Title: Cavalon low fuel float re	Release date 01.Apr. 2019			
SB-C-006 Iss1	Related documents Modification: MC-411 CCAR No.: CCAR-81	Compliance Category: OPTIONAL or		
Applie	RECOMMENDED or			
Aircraft type & model: Cavalon Pro	Aircraft serial Nos. affected: Any RotorSport Cavalon Pro t serial 005	MANDATODY		
The maintenance manual to be referen	e. RSUK0335 Iss1

View of the low fuel sensor assembly

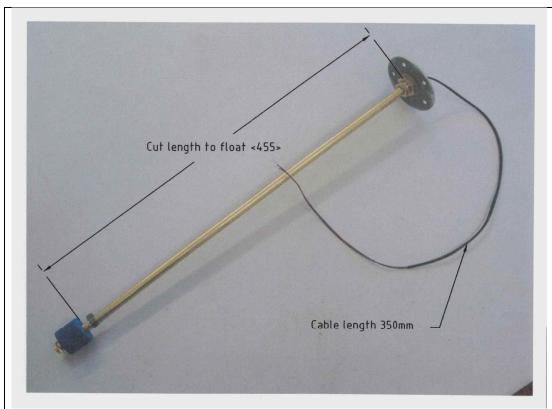
- 7. Remove the blue float and discard. Replace with the new float, with the dot uppermost.
- 8. Refit the split pin and fold out the pin.
- 9. Refit the sensor assy as a reverse of the previous instructions. Use Loctite 5331 sealant on the mating surfaces to seal the assy to the tank.

Photo showing the brass split pin and the float with the marked dot (which is fitted uppermost)
